Limit Switch Wire Rework

Service Bulletin

Furnace Model	Serial Number Range	Field Kit Number	Kit Materials
AFS, AFM, DFS, DFM	73985322 – 81099541	31389	(1) Fiberglass Sleeve: 7" (length) x 1.5" (diameter)

1.2 Placing the sleeve on a DF/AF unit

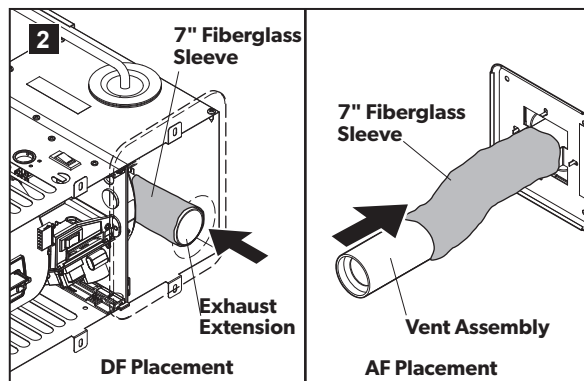
- Remove the vent assembly, and using a flashlight, look through the opening in the vent cover to inspect the exhaust vent area.
- Visually examine the limit switch wires for evidence of the following conditions:
 - Wires laying on the exhaust vent tube
 - Melting at any point along the length of the wire
- If either condition exists, contact the Dometic Technical Service department at 866-869-3118 and/or your OEM manufacturer for repair approval, prior to repairing any wires or continuing with this field repair.
- If no damage is present, proceed with this field repair.

- Install the fiberglass sleeve:
 - For DF units: slide the fiberglass sleeve over the exhaust extension.
 - For AF units: slide the fiberglass sleeve over the vent assembly.
- Re-install the vent assembly.
